Access Compliance Report

Public Rights-of-Way

(Curb Ramps)

Intersection ID: 16319	Main Street: SLOAN_ST	Cross Street: TYSON_ST	Location:	N
ADA ID: CDDCEA1BFB8A	Ramp Type: Perp	Initial Pass/Fail: Fail	Overall Compliance: No	Severity Score: 22.5
Codes/Mitigation Info/Possible Solution		Field Measurements/Component Compliance

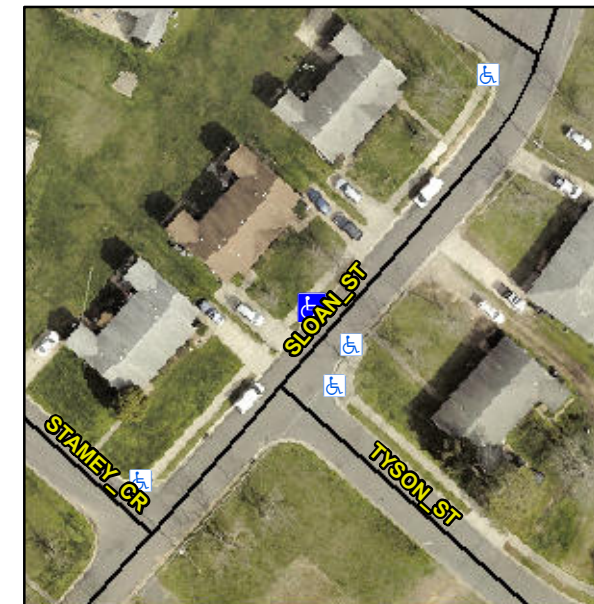
Not Found, R304.5.1, R304.2.2, R304.5.3

Compliance	Description	Data	Compliance	Description	Data
N/A	Ramp Length (in)	42.0	No	Ramp Slope (%)	11.6
No	Ramp Width (in)	47.0	No	Ramp XSlope (%)	4.5
N/A	Flare Type LT	N/A	N/A	Flare Type RT	N/A
N/A	Flare Slope LT (%)	N/A	N/A	Flare Slope RT (%)	N/A
N/A	Flare Traversable LT?	N/A	N/A	Flare Traversable RT?	N/A
N/A	Landing Length (in)	N/A	N/A	DWS Provided?	N/A
N/A	Landing Width (in)	N/A	N/A	DWS Contrast?	N/A
N/A	Landing Slope (%)	N/A	N/A	DWS Length (in)	N/A
N/A	Landing X Slope (%)	N/A	N/A	DWS Full Width?	N/A
N/A	Landing Curb? (Y/N)	N/A	N/A	DWS Offset (in)	N/A
N/A	Shared Landing?	N/A			
N/A	Gutter Ponding?	N/A	N/A	Gutter Slope (%)	N/A
N/A	Gutter Lip Ht (in)	N/A	N/A	Gutter X Slope (%)	N/A
N/A	Painted X Walk1?	No	N/A	Painted X Walk2?	N/A
	X Walk 1 Direction	To SE		X Walk 2 Direction	N/A
N/A	X Walk 1 Width (in)	N/A	N/A	X Walk 2 Width (in)	N/A
	X Walk 1 Slope (%)	4.4		X Walk 2 Slope (%)	N/A
	X Walk 1 X Slope (%)	4.3		X Walk 2 X Slope (%)	N/A

Remove & Replace Entire Ramp.
